Process Sheet

Drawing Name : HELI UTILITY BASKET LH/RH 350/355
 Part Number : D350607043
 Drawing Number : D350-607 REV F P7-9
 Project Number : N/A
 Drawing Revision : F
 Material : N/A
 Due Date : 2/15/2007 Qty: 1 Um: Each

DESIGN <i>CP</i>	DRAWN BY <i>CP</i>	DART AEROSPACE LTD HAWKESBURY, ONTARIO, CANADA	
CHECKED <i>[Signature]</i>	APPROVED <i>[Signature]</i>	DRAWING NO. DSI 9318	REV. A SHEET 1 OF 1
DATE 06.01.06		TITLE WASHER ADDITION	SCALE NTS
A	06.01.06	NEW ISSUE

DART SERVICE INSTRUCTION

Figure 5- Basket Replacement Parts
(D350-607-043 Heli-Utility-Basket™)

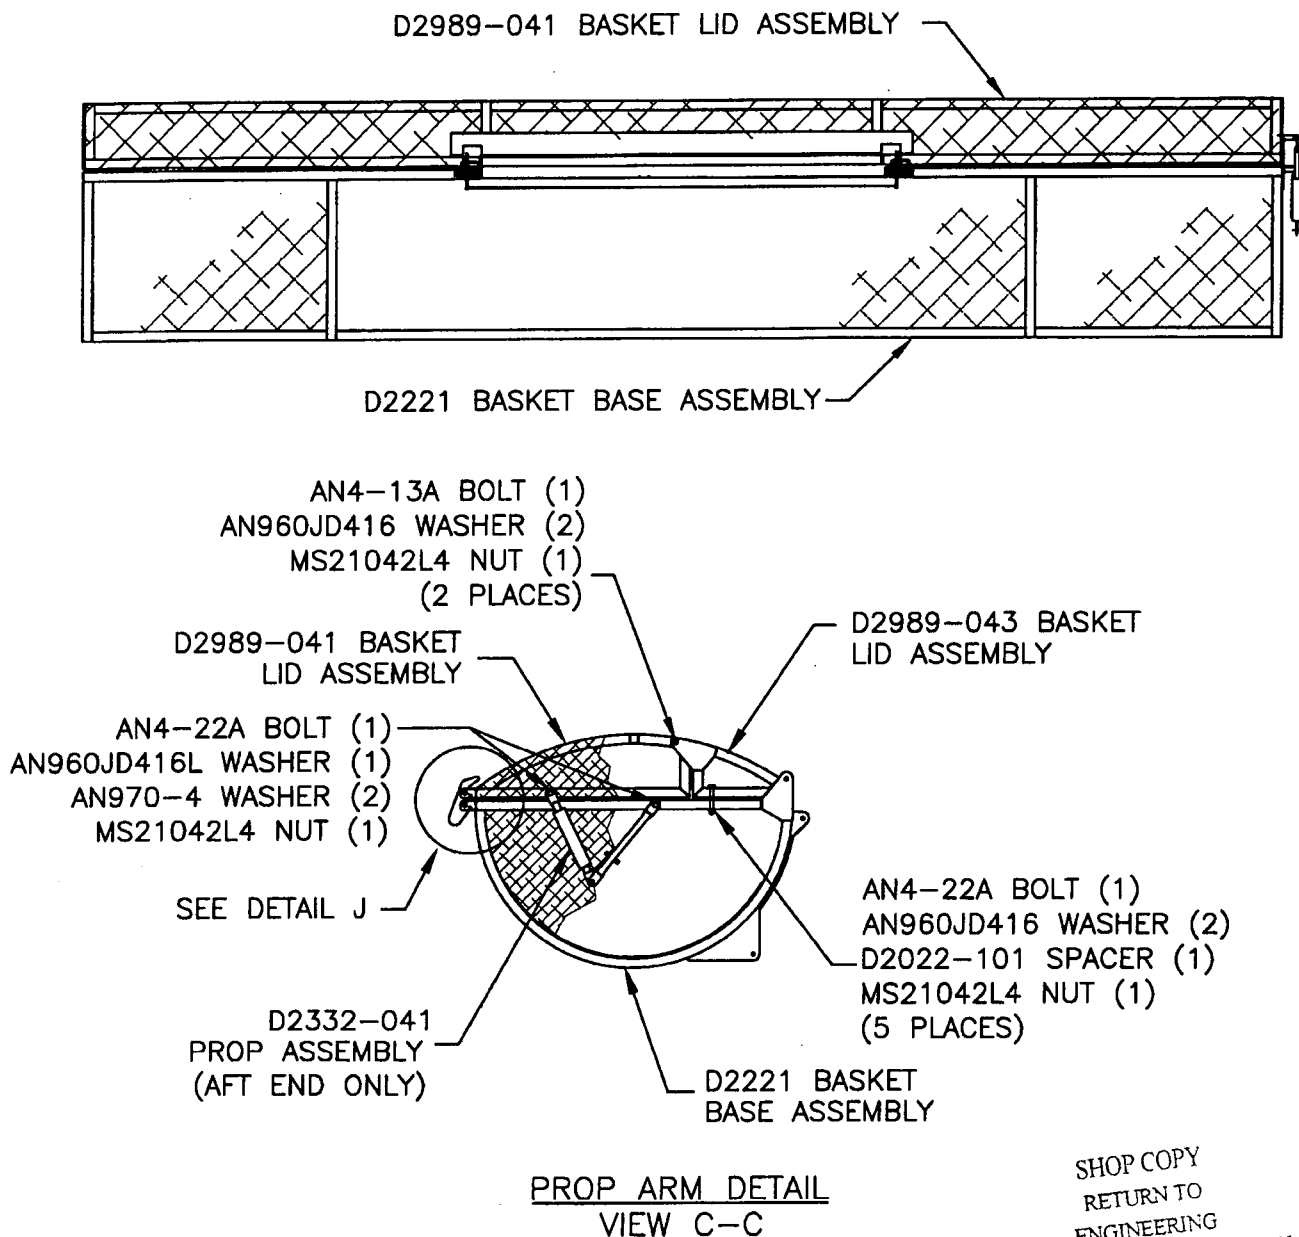
The corrected bolt stackup from Figure 5 of installation instructions D350-607 Rev. F is given below:

AN4-13A BOLT (1)
AN960JD416 WASHER (1)
HINGE PLATE (REF)
NAS1515H4 WASHER (1)
BASKET FRAME (REF)
AN960JD416 WASHER (1)
MS21042L4 NUT (1)
(2 PLACES)

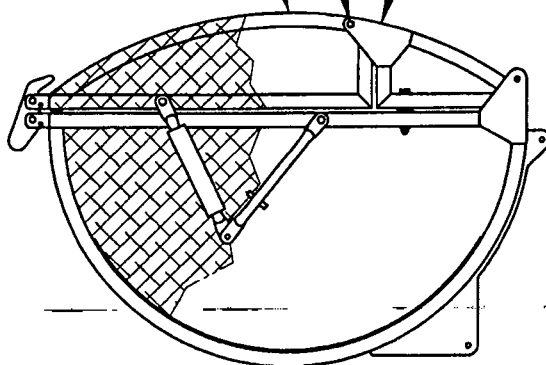
To reduce the possibility of damaging the finish, a **NAS1515H4** washer (2 places) has been added between the hinge plate and basket frame on the **D350-607-043/-047 Heli-Utility-Basket**.
